**Regulation No. 29 (Cabs of commercial vehicles)**

## **Proposal for Supplement 2 to the 02 series of amendments and for Supplement 1 to the 03 series of amendments**

### **Submitted by the expert from Germany\***

Annex 3, Appendix 2,

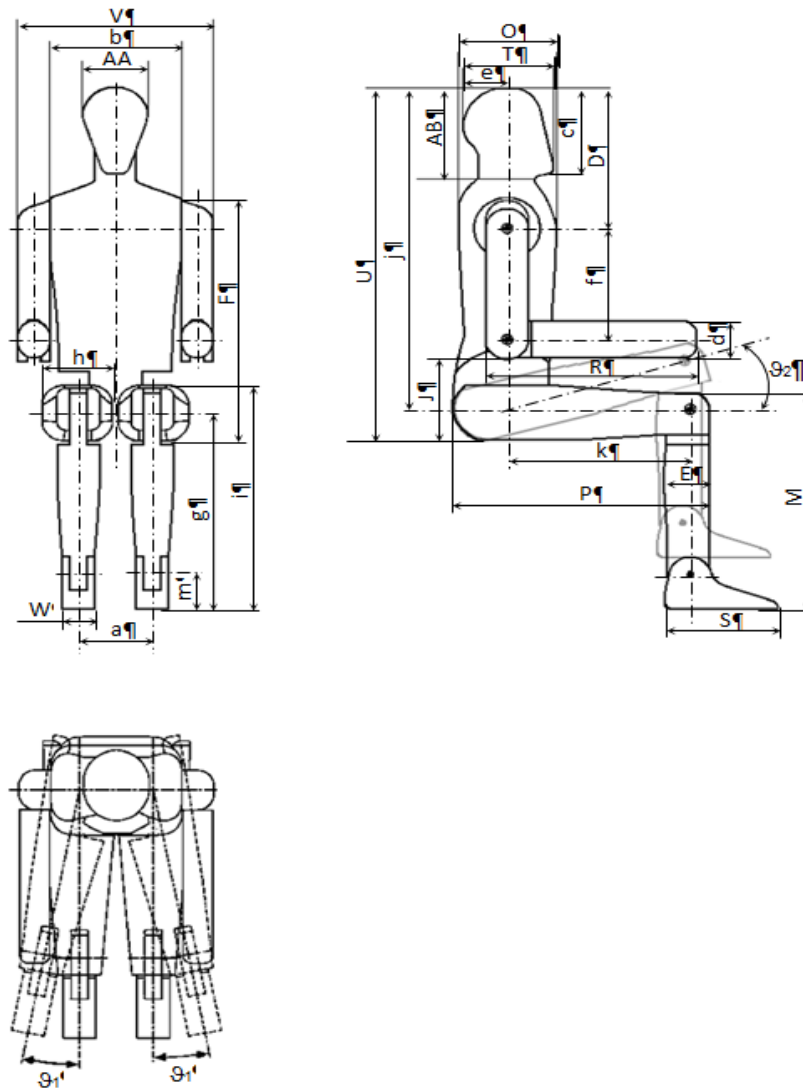
The figure, amend to read:

The table, amend to read:

<i>Material:</i>	Polystyrene; density $0.0169 \text{ g/cm}^3$	
<i>Mass:</i>	4.54 kg	
<i>Dimensions:</i>	...	cm
	...	...
	$\vartheta_1$ Lateral rotation of the legs	$20^\circ$
	$\vartheta_2$ Upward rotation of the legs	$[45^\circ]$
		"

Annex 3, Appendix 2,

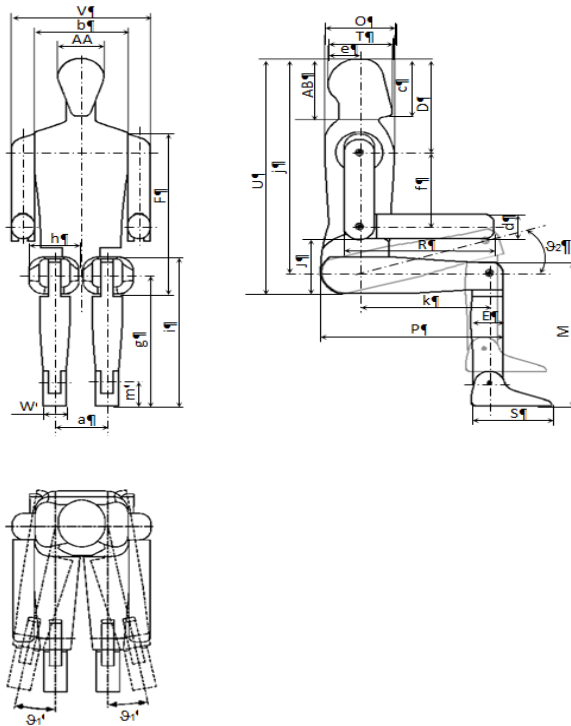
The figure, amend to read:

The table, amend to read:

<i>Dimensions</i>		
<i>Name</i>	<i>Description</i>	<i>Dimension. in mm</i>
AA	Breadth of head	153
...	...	...
$\vartheta_1$	Lateral rotation of the legs	20°
$\vartheta_2$	<b>Upward rotation of the legs</b>	<b>[45°]</b>
